CERTIFICATE OF APPROPRIATENESS

Property: 1418 Ashland Street, Lot 25, Tract 24 and 26A, Block 152, Houston Heights Subdivision. The property includes a historic 1,194 square foot single family residence situated on a 8,712 square foot (66' x 132') interior lot.

Proposal: Alteration – Addition (*Revision*)

The applicant received a COA to construct a two-story 2,613 square foot addition in December 2015. The applicant now proposes the following revisions:

3D RENDERING – FRONT FACING ASHLAND STREET

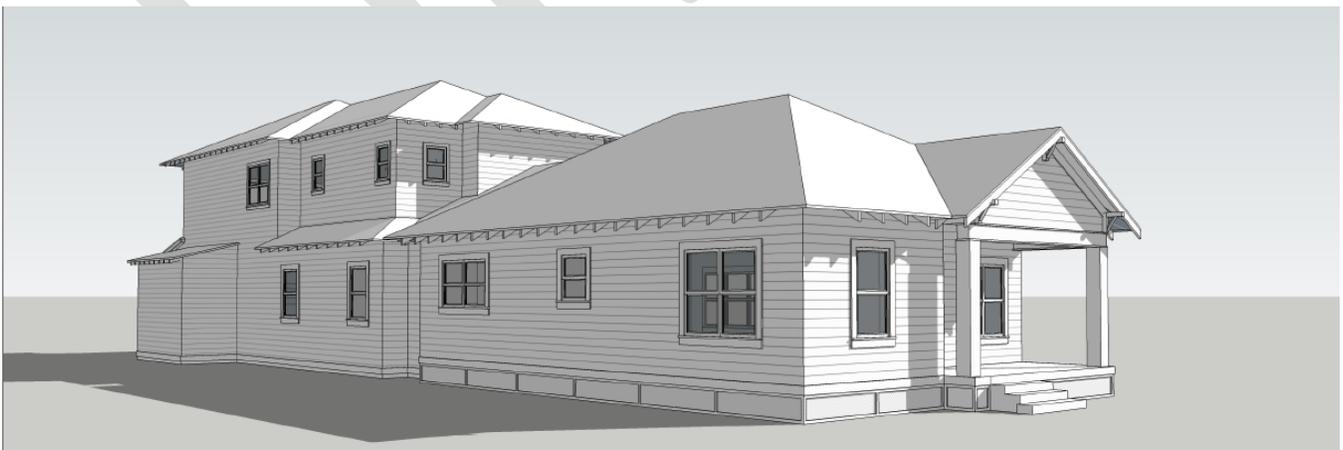
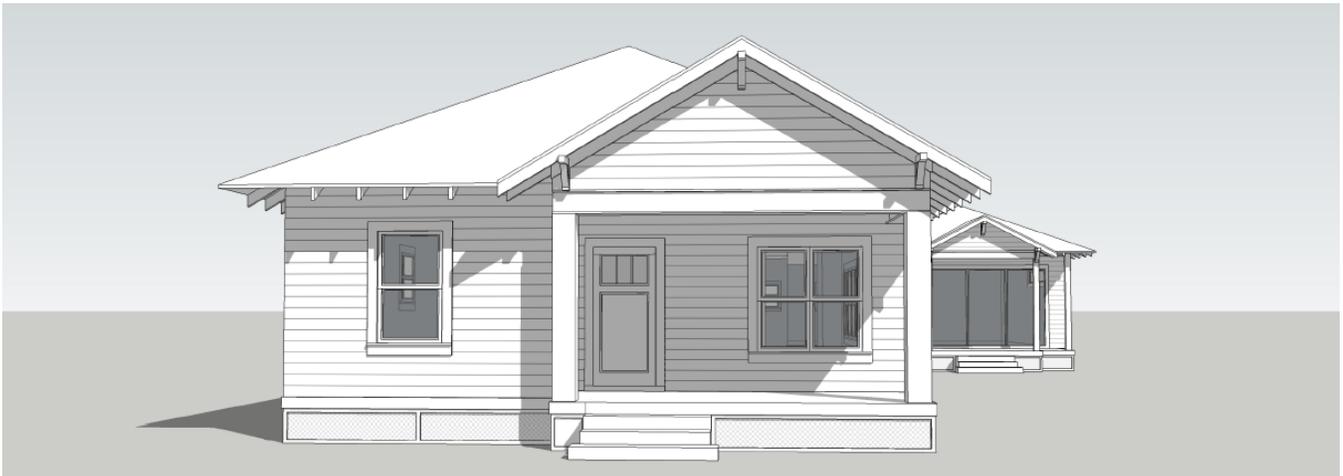
- Install a new craftsman style 3-lite front door at the restored front porch.
- Eliminate square wood railings and arch at the restored front porch and one-story portion of the addition.
- Remove a non-original louvered vent from the front-facing gable.
- Eliminate four wood windows from the west (front) elevation of the one-story portion of the addition, and replace with two sets of two single-lite sliding glass doors.
- Remove a non-original paneled side door and replace with a 1-over-1 wood window in the same location on the existing residence.
- Eliminate two windows from the second level of the north (side) elevation of the addition.

WEST ELEVATION – FRONT FACING ASHLAND STREET

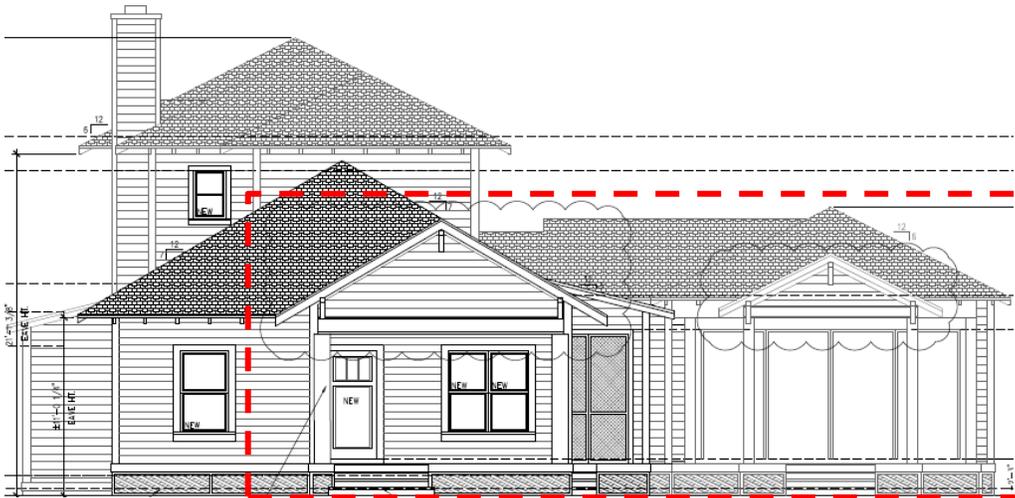
Proposed: A non-original louvered vent on the porch canopy will be removed. The square wood railings have been eliminated from the design on the porch and addition. The one-story portion of the addition will feature two pairs of single-lite sliding glass doors.

SOUTH SIDE ELEVATION
EXISTING

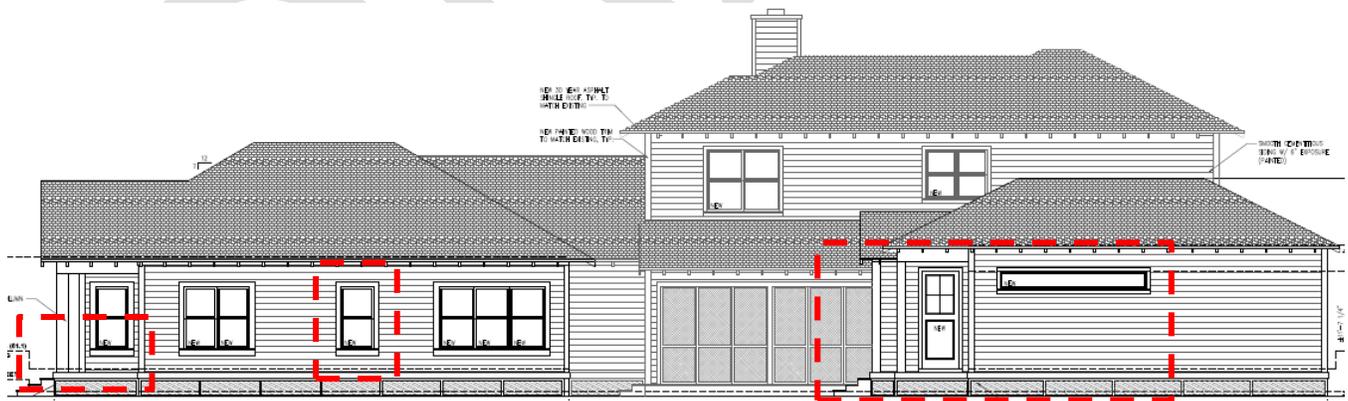
Proposed: A non-original side door will be removed and replaced with a new 1-over-1 wood window in the same location. Five single-lite casement windows on the first level of the addition have been eliminated and replaced with one single-lite fixed window.

NORTH SIDE ELEVATION
EXISTING

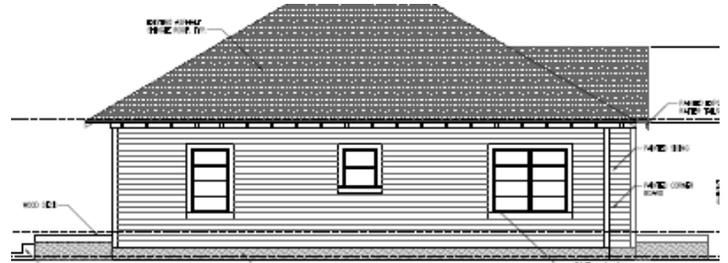
Proposed: Two windows have been eliminated from the second level of the addition.
